## ADDENDUM NO. 04

MOUNTAIN TRANSIT MAINTENANCE FACILITY

**FOR THE**  
MOUNTAIN AREA REGIONAL TRANSIT AUTHORITY (MARTA)

RCA Project No. 5-08-01

**EQUIPMENT SCHEDULE**

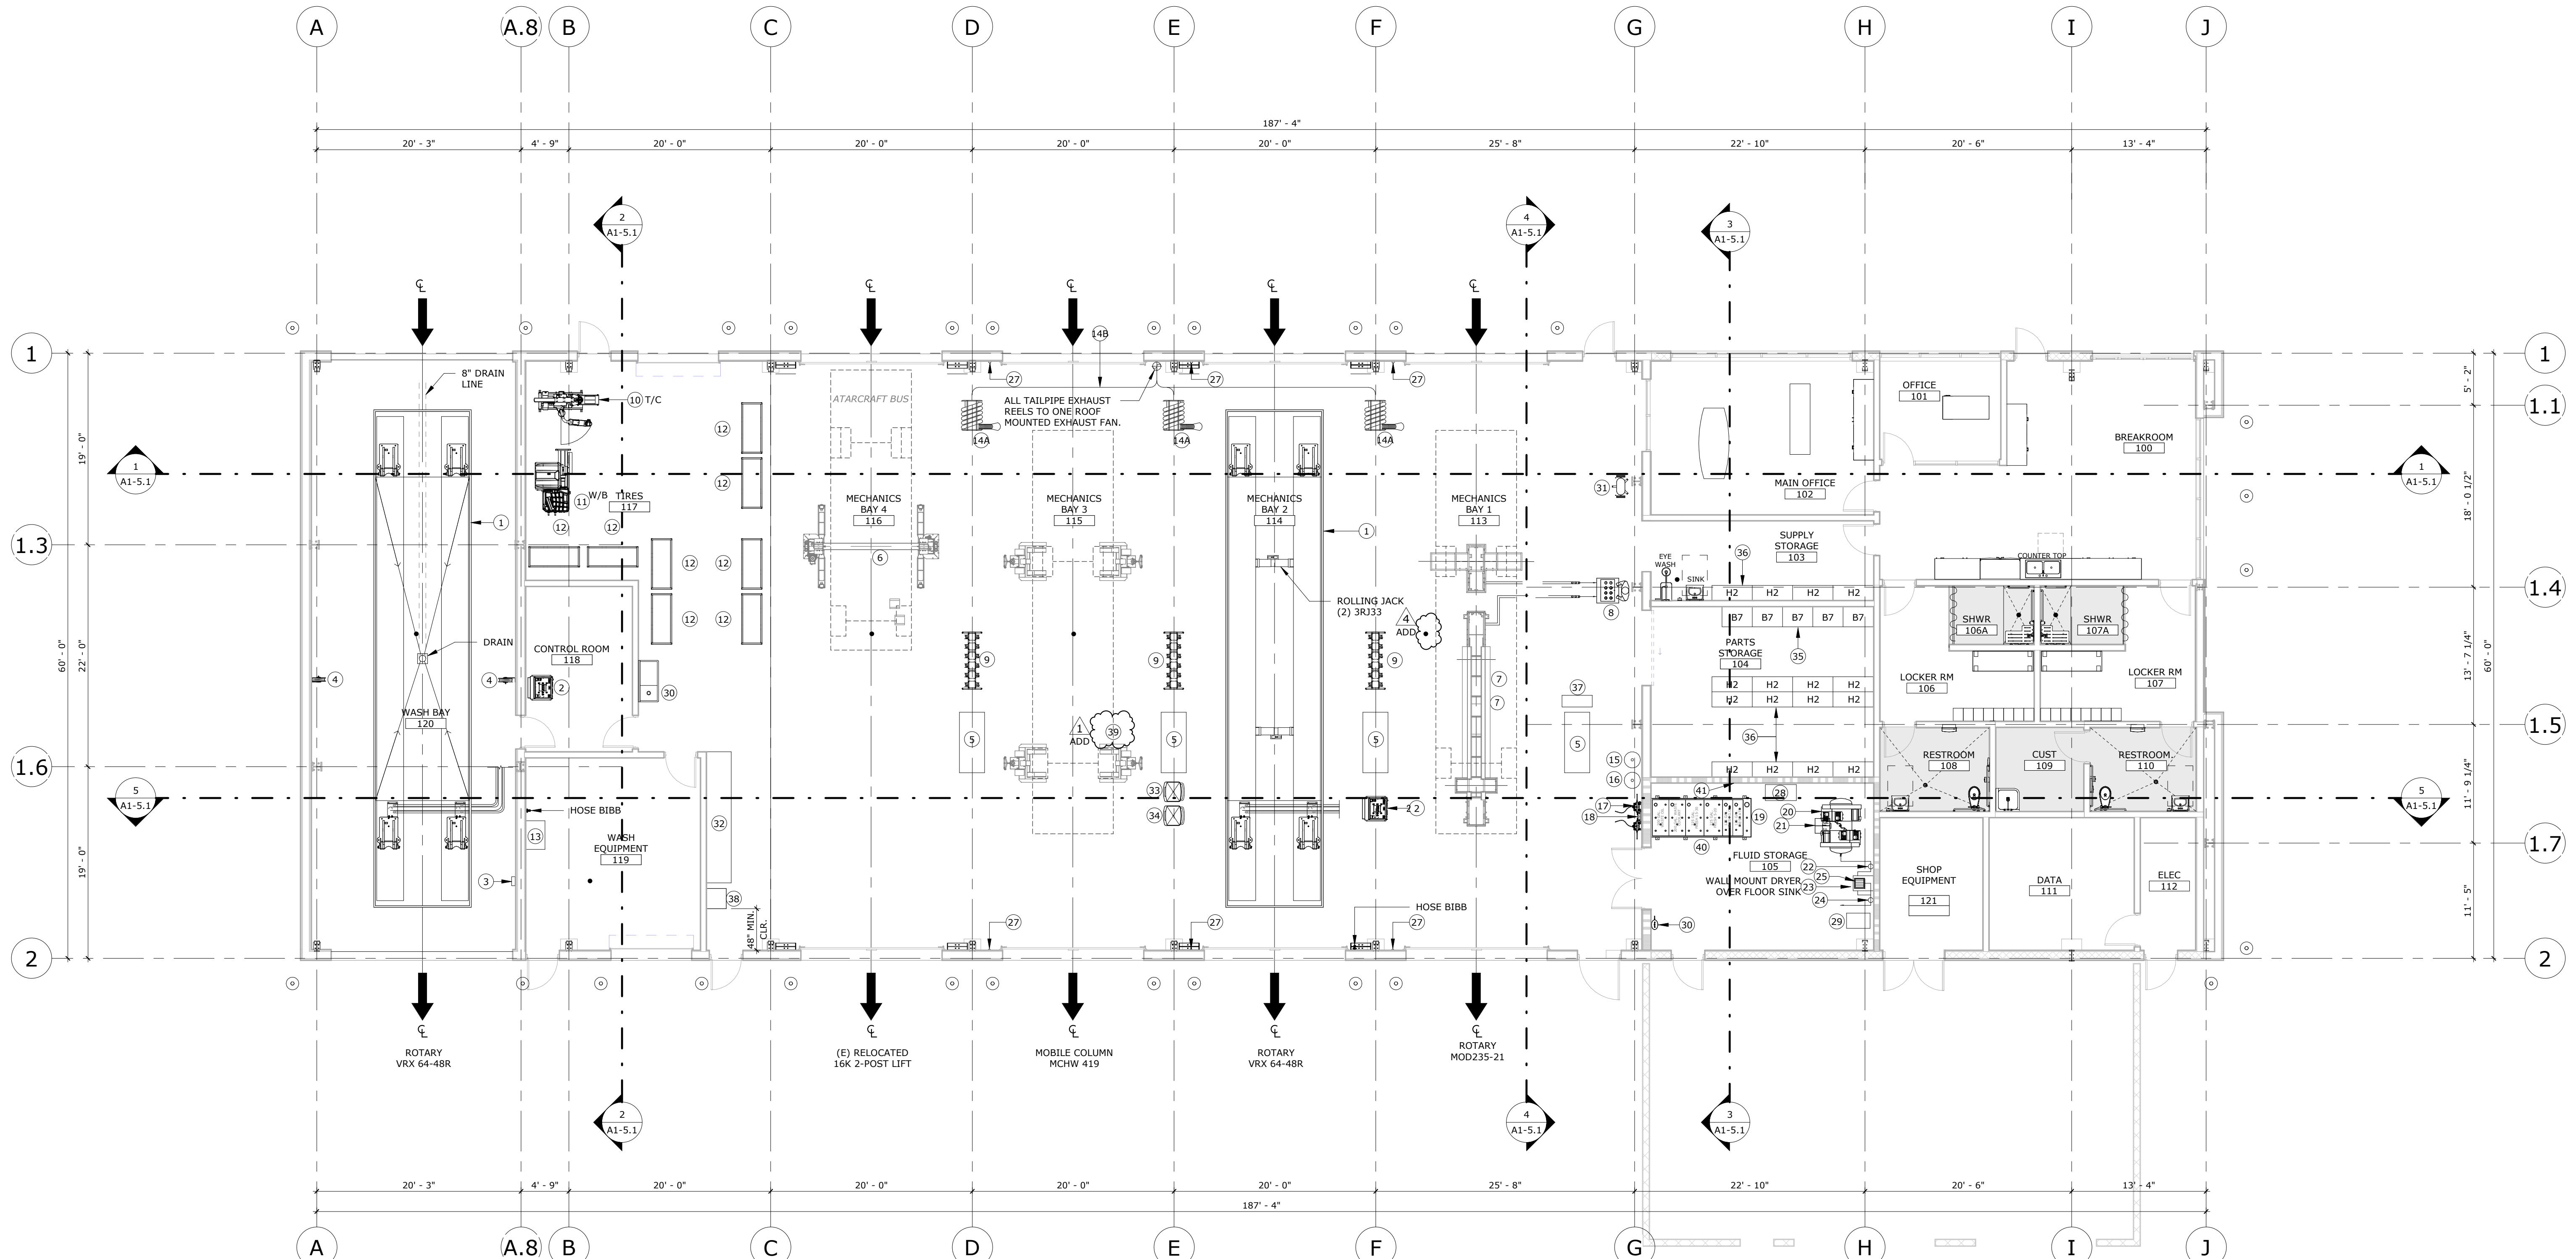
- Item No. 4.21 Reference Sheet A1-1.3 – Equipment Plan
- 4.21.1 Replace Sheet A1-1.3 and revise per clouded areas listed below:
- a) Revised Equipment Schedule per clouded areas.
    - a. Revised Purchase / Installation column per clouded area.
    - b. Revised Keynote #1 per clouded areas.
    - c. Revised Keynote #12 per clouded area.
    - d. Revised Keynote #13 per clouded area.
    - e. Revised Keynote #15 per clouded area. Misspelling error.
    - f. Revised Keynote #19 per clouded area.
    - g. Revised Keynote #30 per clouded area.
  - b) Revised Equipment Plan 1/A1-1.3 per clouded area.
    - a. Added equipment keynote #39 to plan.
    - b. Relocated floor drain in Mechanics Bay #113

**PEMB WIN. HEAD INSET** SCALE: 3" = 1'-0" REF.: 1/A1.8.1

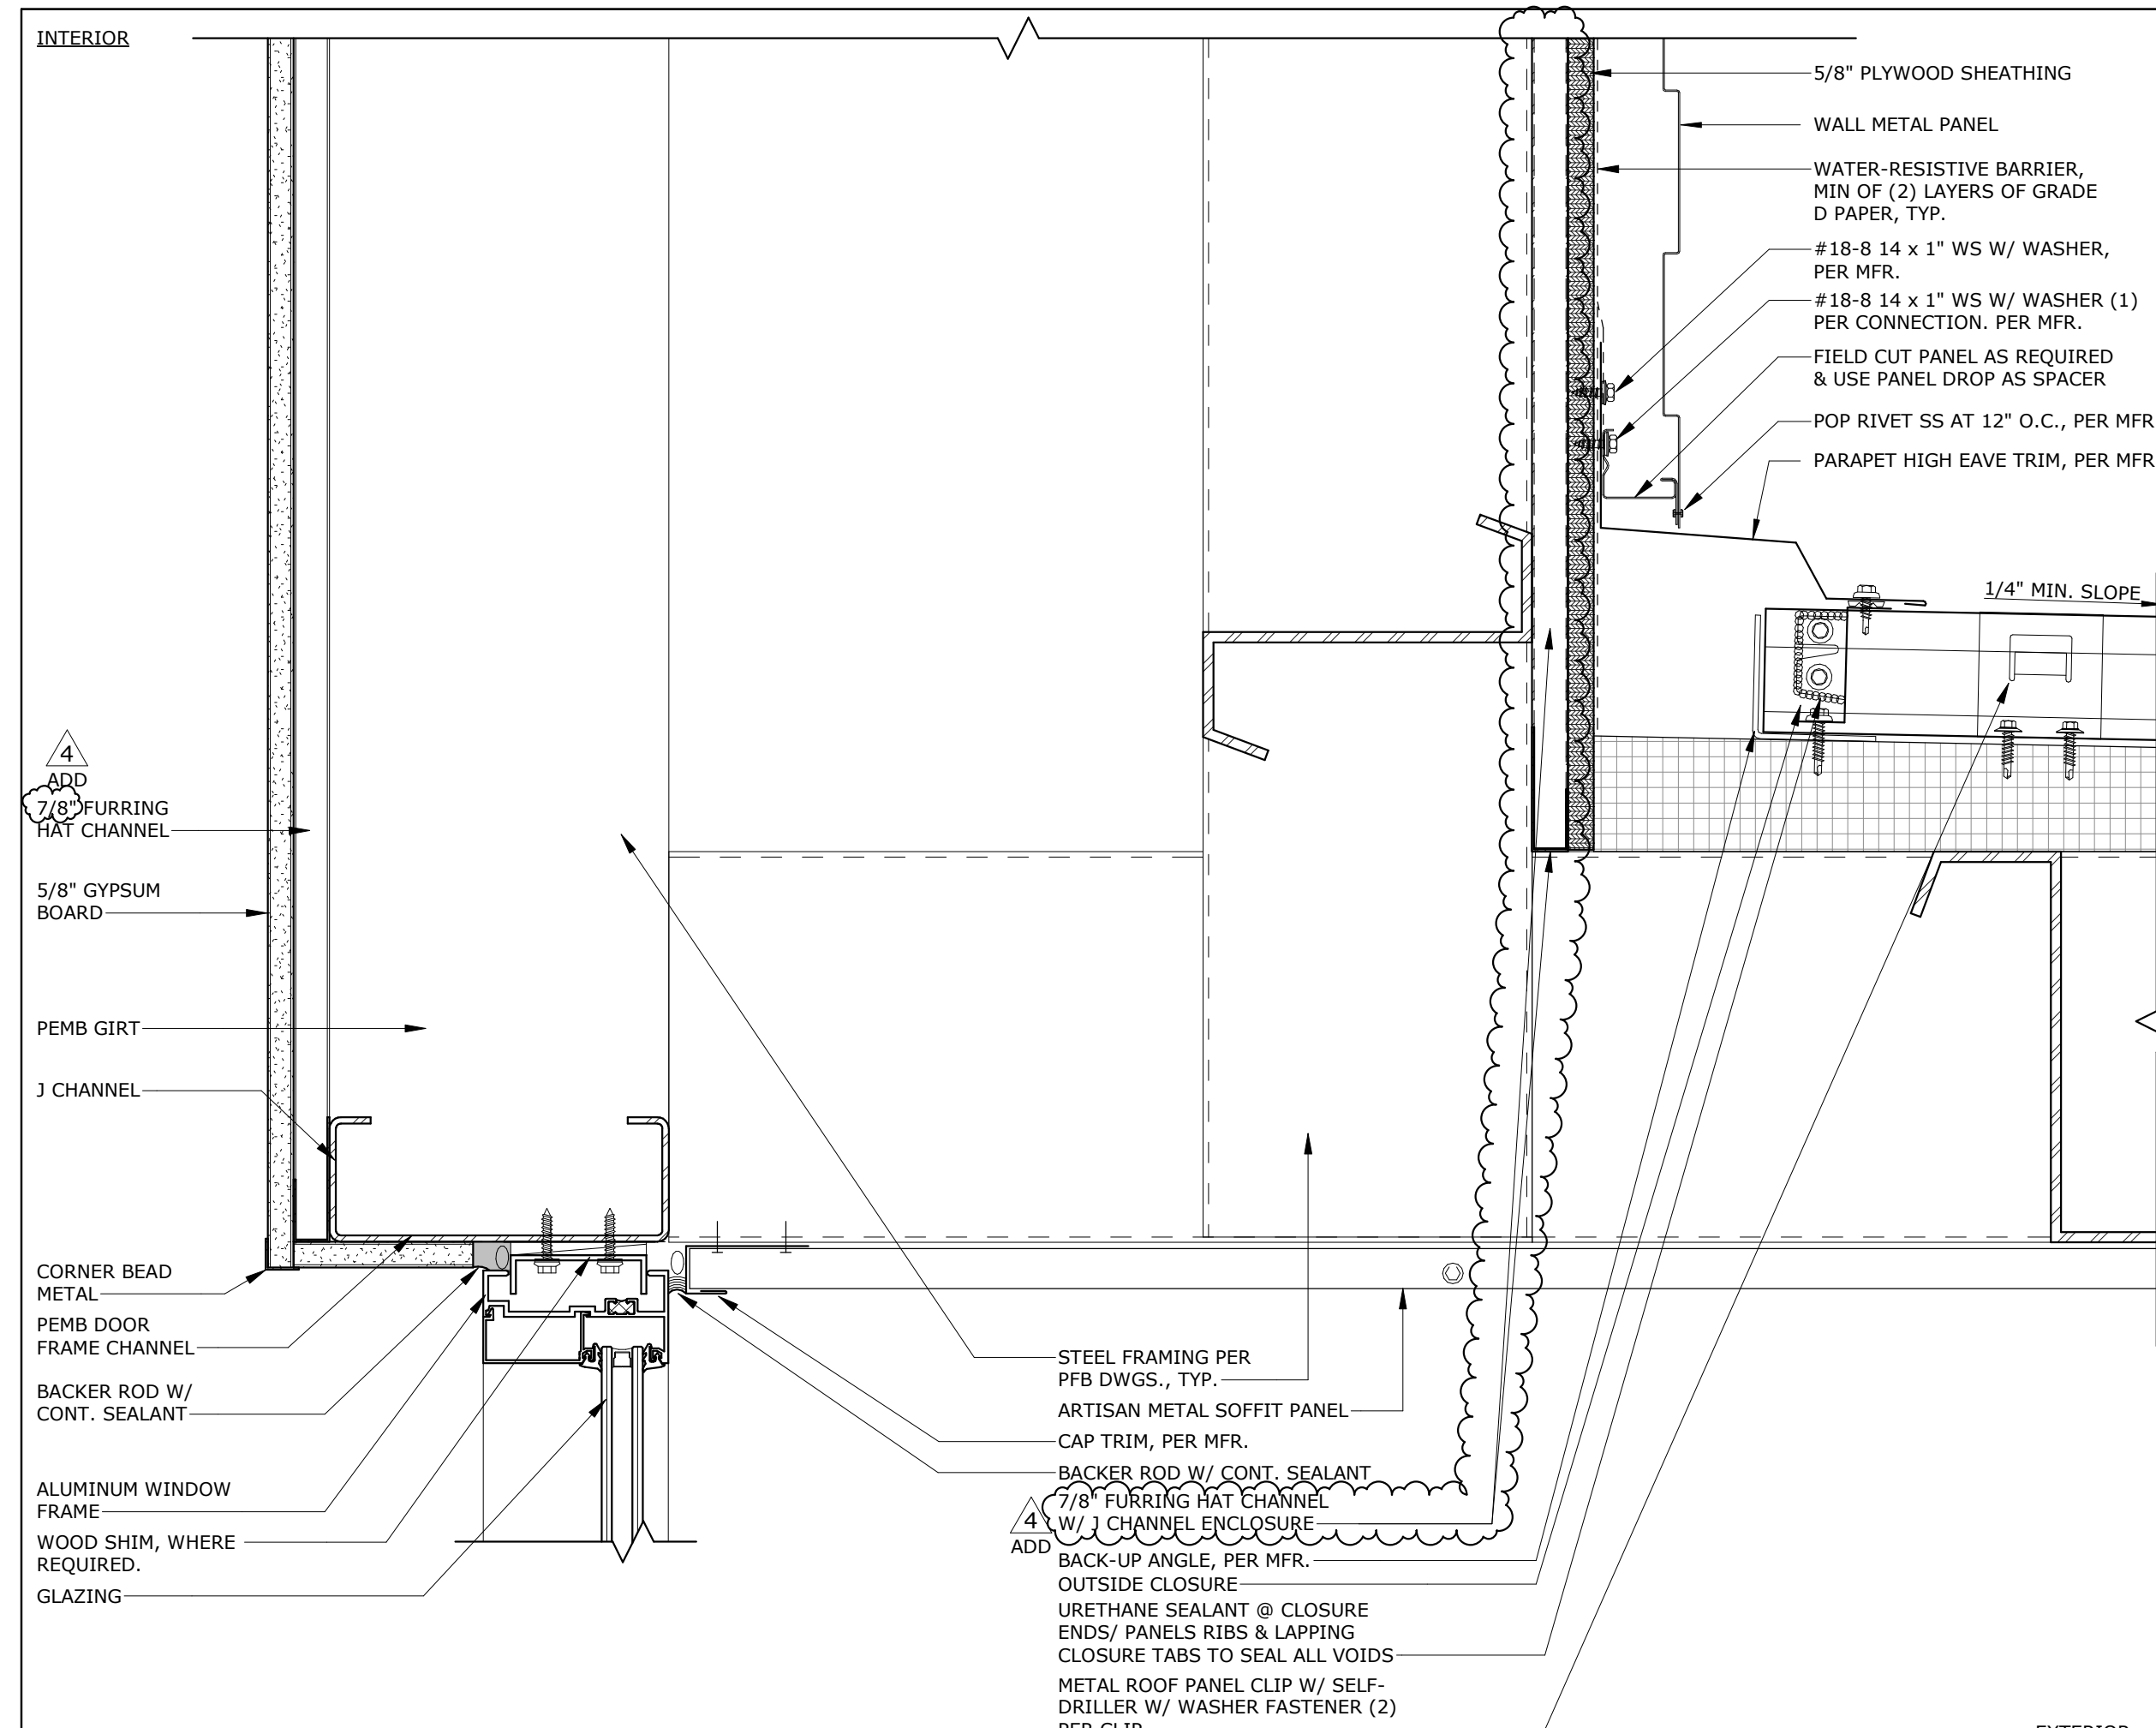
- g) Revised detail 14/AD-6.1 – Ext. HM. Door Jamb 2 per clouded area. Added 7/8" furring hat channel.
- h) Revised detail 21/AD-6.1 – PEMB Win. Head Inset per clouded area. Added 7/8" furring hat channel.
